Access Compliance Report

Public Rights-of-Way

(Curb Ramps)

Intersection ID: 30149	Main Street: RUMPLE_RD	Cross Street: HEMBY_WOODS_DR	Location: N
ADA ID: 477CF599EAD2	Ramp Type: PerpDiag	Initial Pass/Fail: Fail	Overall Compliance: No
Severity Score: 33.75			
Codes/Mitigation Info/Possible Solution		Field Measurements/Component Compliance

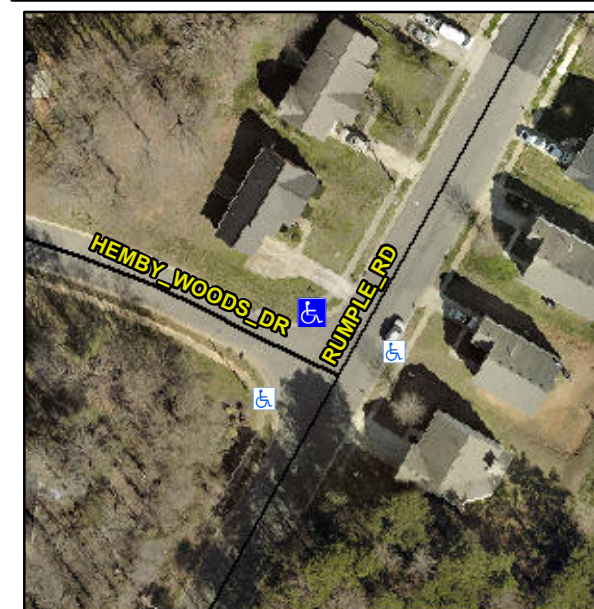
Not Found, R304.5.1, R304.5.3

Compliance	Description	Data	Compliance	Description	Data
N/A	Ramp Length (in)	95.0	Yes	Ramp Slope (%)	6.8
No	Ramp Width (in)	46.5	No	Ramp XSlope (%)	7.6
N/A	Flare Type LT	N/A	N/A	Flare Type RT	N/A
N/A	Flare Slope LT (%)	N/A	N/A	Flare Slope RT (%)	N/A
N/A	Flare Traversable LT?	N/A	N/A	Flare Traversable RT?	N/A
N/A	Landing Length (in)	N/A	N/A	DWS Provided?	N/A
N/A	Landing Width (in)	N/A	N/A	DWS Contrast?	N/A
N/A	Landing Slope (%)	N/A	N/A	DWS Length (in)	N/A
N/A	Landing X Slope (%)	N/A	N/A	DWS Full Width?	N/A
N/A	Landing Curb? (Y/N)	N/A	N/A	DWS Offset (in)	N/A
N/A	Shared Landing?	N/A			
N/A	Gutter Ponding?	N/A	N/A	Gutter Slope (%)	N/A
N/A	Gutter Lip Ht (in)	N/A	N/A	Gutter X Slope (%)	N/A
N/A	Painted X Walk1?	No	N/A	Painted X Walk2?	No
	X Walk 1 Direction	To SW		X Walk 2 Direction	To SE
N/A	X Walk 1 Width (in)	N/A	N/A	X Walk 2 Width (in)	N/A
	X Walk 1 Slope (%)	7.6		X Walk 2 Slope (%)	0.4
	X Walk 1 X Slope (%)	1.3		X Walk 2 X Slope (%)	4.8

N/A	Ramp inside XWalk1?	N/A	N/A	Ramp inside XWalk2?	N/A
	Road Slope (%)	6.8	N/A	Clear Space?	N/A
	Road X Slope (%)	1.7	N/A	Clear Space to XWalk (in)	N/A
N/A	Any Obstructions?	N/A	N/A	Storm Grate/Utility Hazard?	N/A
	Obstruction Type			Storm Grate/Utility Type	
		N/A			N/A
		Yes		Surface Condition? (G/P)	Good

Remove & Replace Curb Ramp With Two New Directional Ramps or Equivalent.
